**STAFF REPORT**  
**(One-Step Final Plat)**

**CASE NUMBER:** SUB 2000-56 -- ELLSON COURT ADDITION

STAFF REPORT

(Revised One-Step Final Plat; Approved 7/20/00)

Water Mark Profile

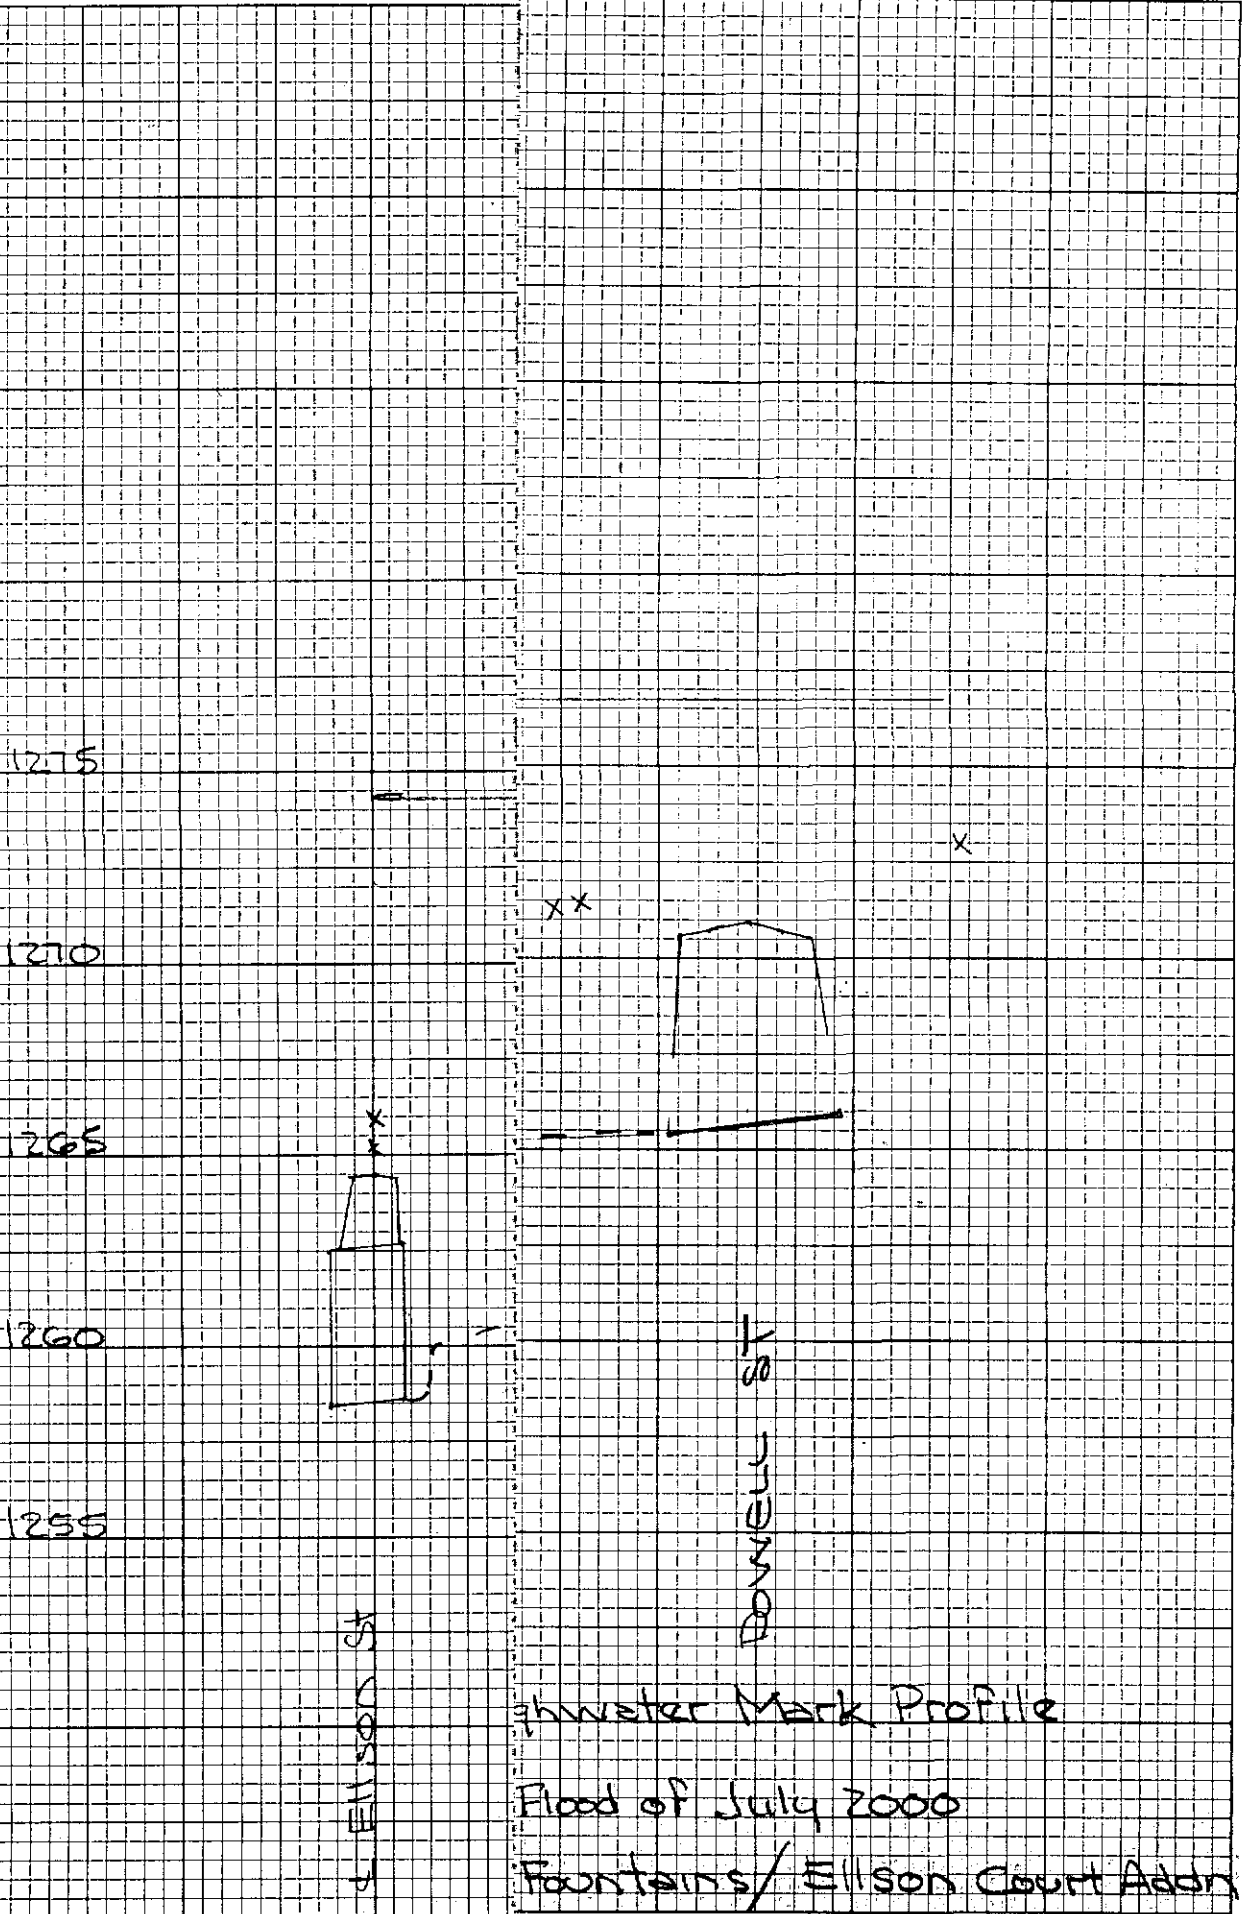
On July 30, in company of one of the residents and the Mr. Allam, I set a series of "highwater marks" along the route of the drainage channel leading from west of Dowell to the Fountains Second Addition detention pond, then across the floodway platted in New Life Christian Church Addition to where it crosses Ellson Street.

Griffiths & Associates surveyed the location and elevation of those "highwater marks" and produced a drawing showing the position of those marks with respect to lots in the Fountains Second Addition and to Ellson Street. On that drawing, I sketched a base line of the watercourse from the Dowell Street culvert, through the Fountains Second detention weir and culvert, then to the culverts under Ellson Street. I then drew a profile of that base line, sketched in a thalweg of the stream and plotted a profile showing each of the highwater marks in relation to the top of Ellson Street, the weir at the Fountains Second detention pond outlet and the top of Dowell Street at the culvert.

That exercise demonstrates that flooding downstream from the Fountains Second Addition detention pond outlet, and the detention pond and outlet itself had no "backwater effect" on the highwater elevations located either side of Dowell Street. The problem with water overtopping Dowell Street appears to be caused by an increase in runoff from recent improvements of drainage along Greenwich Road, along Central Avenue and the Greenwich Road frontage contributing to the culvert under Dowell Street, or the loss of stormwater storage in that area.

It is recommended that the combined talents of the City and County engineering staff along with engineers representing developers of the area east of Greenwich Road study the area contributing to the Dowell Street culvert before any additional development is permitted which may make it difficult or impossible to correct the situation reflected by this study.

I was advised by Mr. Jednoralski that MKEC would revise the minimum building pad elevations for Ellson Court Addition to reflect the fact that water has gone over Ellson Street by an amount estimated to be as much as 1 ½ to 2 feet which is consistent with one of the "high water marks" I set.
